Subject: AP1000 Response to Request for Additional Information

1. Response to Request for Additional Information on SRP Section TR44

AP1000 TECHNICAL REPORT REVIEW

RAI Response Number: RAI-TR44-008

Figure 9.1.1 (Sheet 1 of 2)
New Fuel Storage Rack Layout (72 Storage Locations)

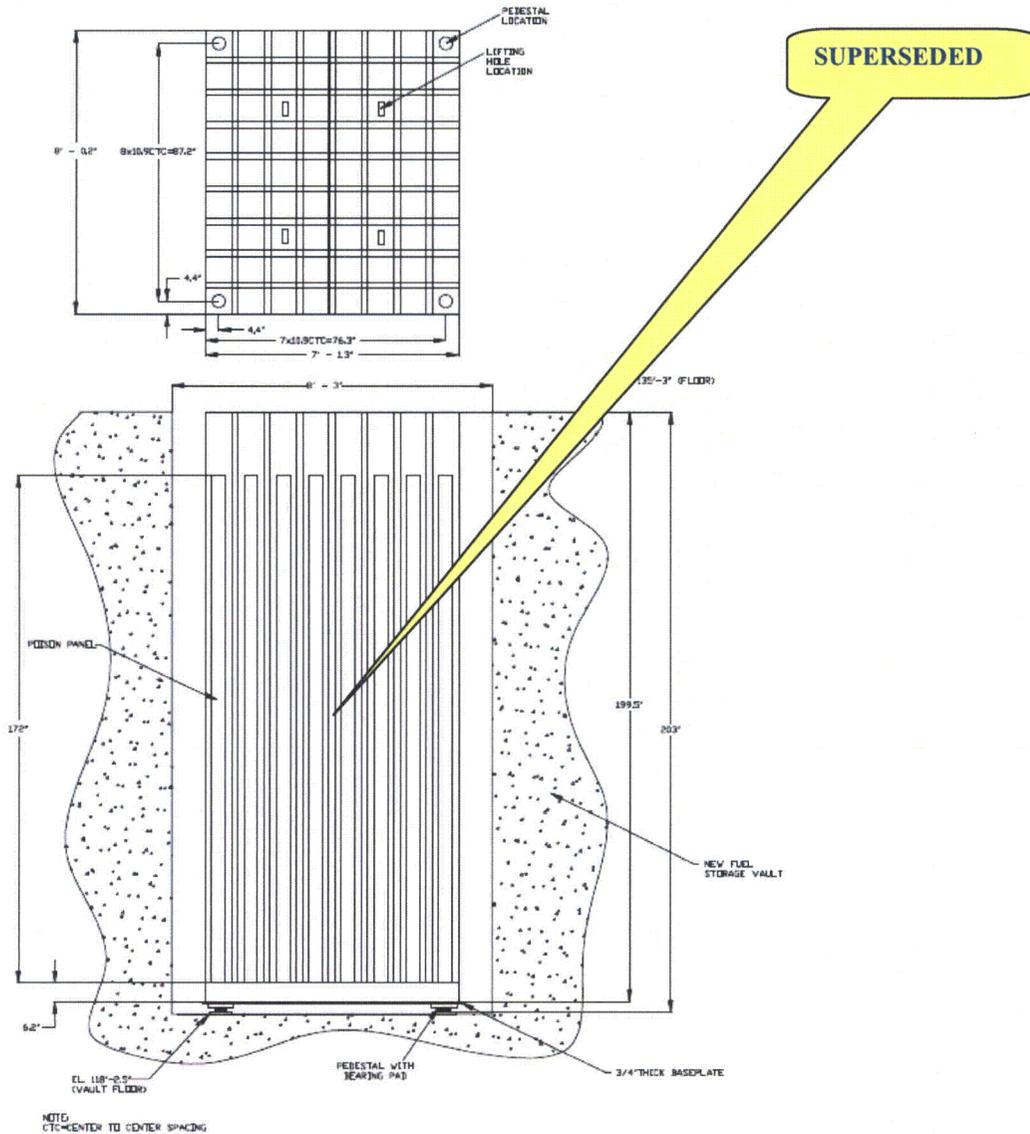
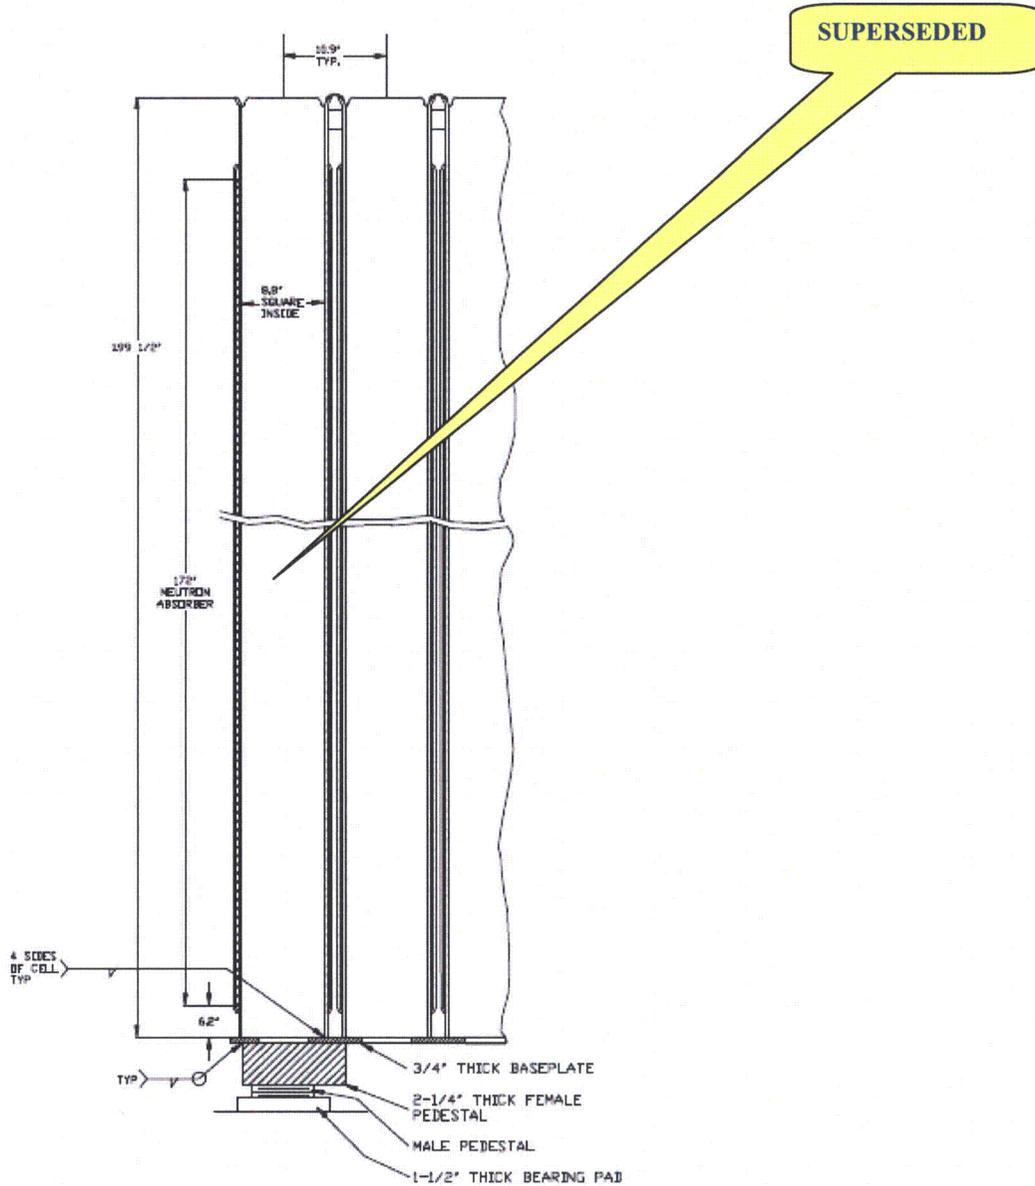
In the markup of the DCD, provided in Section 5 of the topical report, Figure 9.1-1, New Fuel Storage Rack, is identified for deletion. Please explain why you are deleting this figure. This figure should be retained in the DCD.

During the June 2010 audit, the NRC requested that dimension and gap information for the new fuel racks be clarified between the three similar RAIs (RAI-TR44-09, RAI-TR44-017, RAI-TR44-25) to show consistency and alignment to the current design basis shown in DCD Figure 9.1-1.

The most recent change to DCD Figure 9.1-1 (Sheet 1 of 2) is included in the response to RAI-TR44-17 Revision 3.

The DCD Figure 9.1-1 (Sheet 2 of 2) is not modified by any revision of comments in this RAI response. This figure and page were included into DCD Revision 17 (Letter DCP/NRC 2202) and remain applicable to the new fuel rack design.

~~Figures 9.1-1 (Sheet 1 of 2) and Figures 9.1-1 (Sheet 2 of 2) are changed as shown below.~~
